**TSG-RAN Meeting #11
Palm Springs, CA, U.S.A., 13-16 March 2001**

RP-010122

Title: Agreed CRs to TS 25.427

Source: TSG-RAN WG3

Figure 23: Structure of the Timing Advance control frame

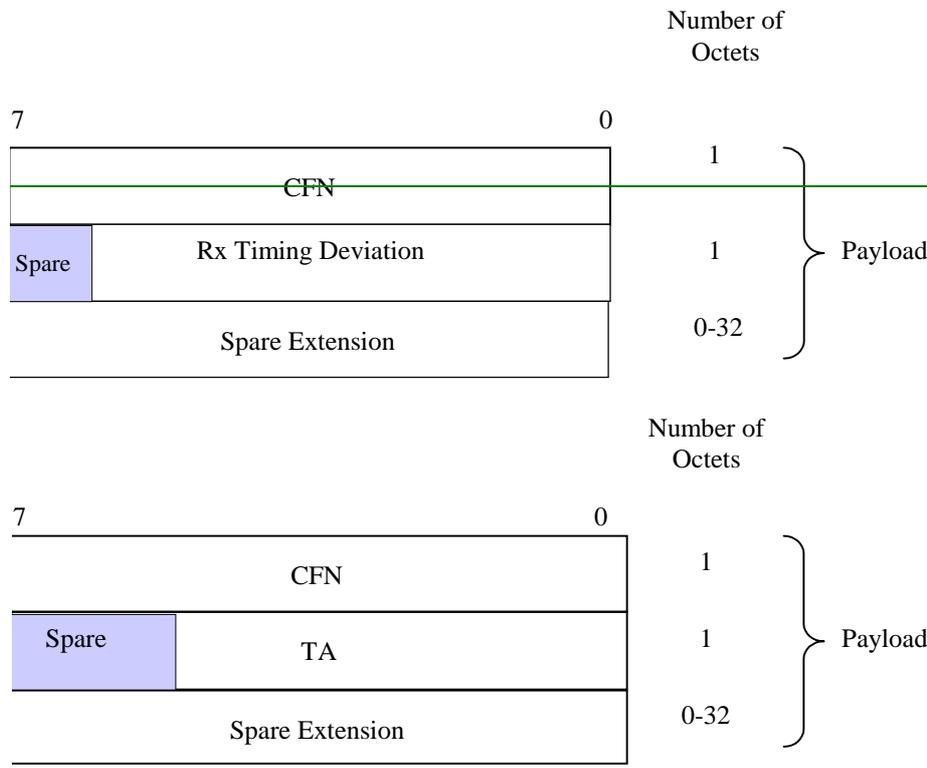
Reason for change:	<p>In RAN WG3 #17 meeting, R3-2802(CR37r1) & R3-2628(CR38) had been approved <u>and they were approved in RAN #10. but-But they were not implemented correctly in the specification by MCC team so TS25.427 v.3.5.0 contains errors there were some mistakes when implemented in the specification.</u></p> <p>This contribution corrects those errors.</p>
Summary of change:	<p>rev 1 : Cover was revised : adding backward compatibility statement and the clarification of reason for change</p> <ol style="list-style-type: none"> 1. In chapter 5.6, ")" was added. 2. Correct version of figure 23 was inserted.
Consequences if not approved:	<p>Specification will have errors.</p> <p>Backward compatibility : This CR is backward compatible with the intended behaviour of the previous version of specification. However, since previous version has errors, some implementation made with wrong information may not be compatible with this CR.</p>

Clauses affected:	5.6, 6.3.3.10.1	
Other specs affected:	<input type="checkbox"/> Other core specifications <input type="checkbox"/> Test specifications <input type="checkbox"/> O&M Specifications	
Other comments:
